## SB, 265 RX, Clutch, 2002-05

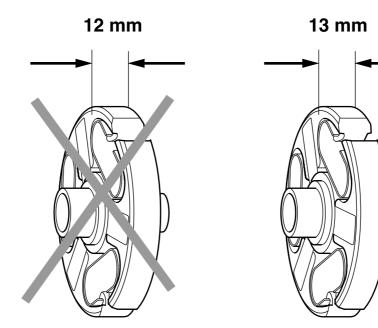
We have made the clutch shoes 1 mm wider to increase the weight and hence reduce slipping of the clutch.

The clutch shoes retain their original part no., 537 09 77-01. The clutch assembly also has the same part no. as before, 537 09 95-01. The wider shoe has revision letter C. It is 13 mm wide compared with the earlier 12 mm.

Never mix a narrow clutch shoe with a wide clutch shoe when refurbishing a clutch. This would unbalance the clutch, and the clutch shoes would engage at different speeds. This could cause serious engine damage.

Introduced from serial number: 020400116
